DINETTE TABLE PRODUCT IMPROVEMENT

Bulletin Type:	PIN	Publication Date:	May 2021
Bulletin #(s):	21-014	Make(s):	Jayco
Job Code(s):	N/A	Model(s):	Eagle HT TT
Flat Rate(s):	N/A	Model Year(s):	2021

Incident:	Dinette table top tilting in bed position when pressure is added
Affected Units:	- 2021 Jayco 264BHOK Eagle HT TT - 2021 Jayco 284BHOK Eagle HT TT - 2021 Jayco 272RBOK Eagle HT TT
Parts List:	- 2 – L-brackets (Jayco Part #2027201)
Misc. Tools & Supplies:	- Compact drill
Parts Return Information:	- N/A

FIG 1

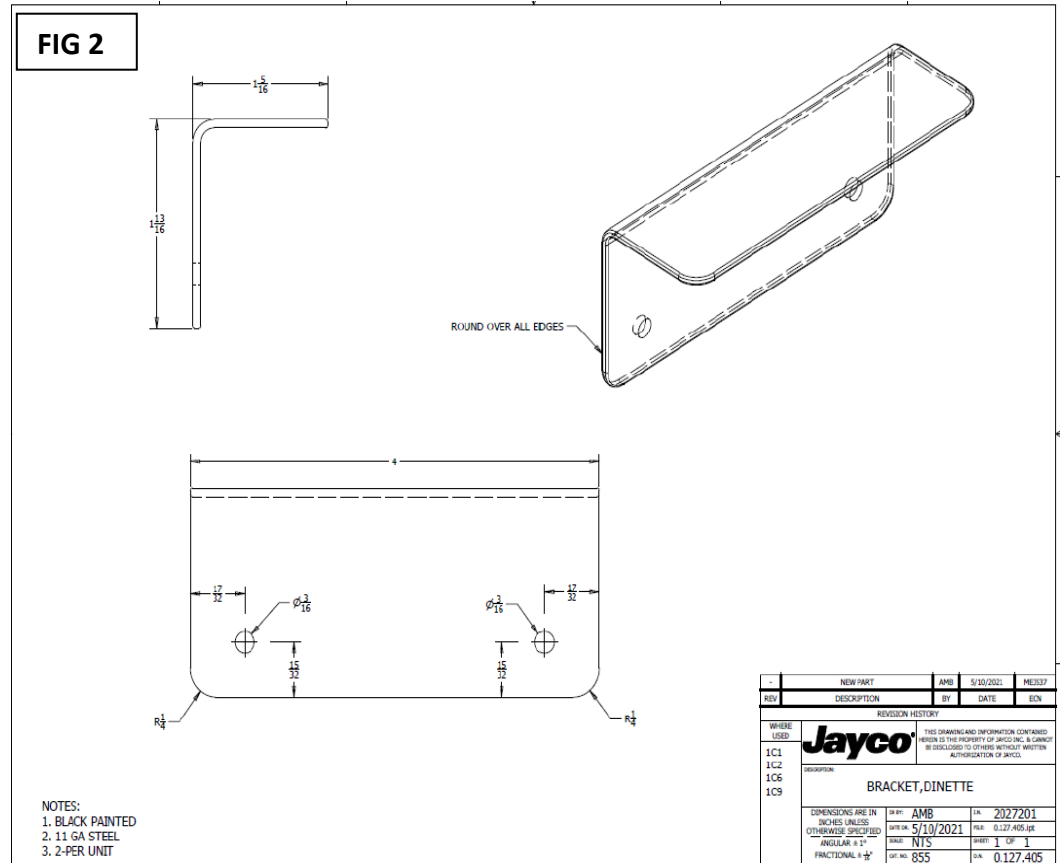
1. Fig 1 illustrates the Dinette Table in bed position. The red circles shows the location of the cleats under the table which will be removed in steps 2-5.

- Figure 2 shows the additional L-brackets that will be added to the cleats for additional strength.

- Remove the two cleats shown in figure 1 and keep the 1 3/4" cabinet set fasteners.
- Install two L-brackets shown in fig 3 along with the cleat on the black plastic support with the 1 3/4" cabinet set fasteners. Do this process on the other side as well.
